OCONEE NUCLEAR STATION, UNITS NO. 1 AND 2  
DOCKET NO. 50-269 AND 270 / RENEWED LICENSE NO. DPR-38 AND DPR-47

**SUBJECT: Response to Request for Additional Information for Proposed Alternative to Repair/Replacement Activities on Low Pressure Service Water (LPSW) Piping**

**Duke Energy Response to Request for Additional Information**

**Data Map Showing As Found Thickness Values Associated with the  
Through-Wall Leak**

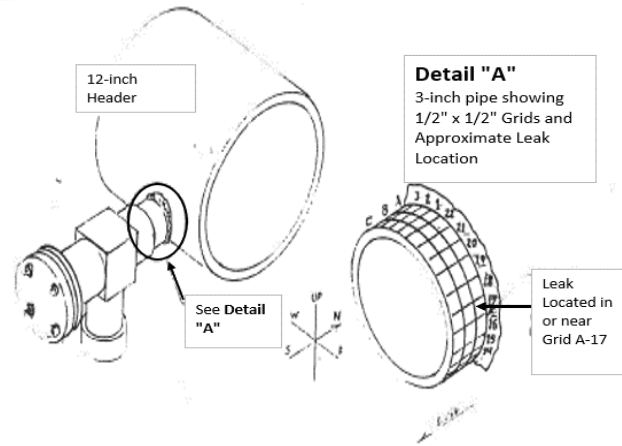
- b. Please provide a map of the as found pipe wall thickness readings this should also identify the locations where the encapsulation is proposed to be attached to the existing piping.

Please see map and sketch showing the as found data at the leak location (Attachment 1, Data Map Showing As Found Thickness Values Associated with the Through-Wall Leak).
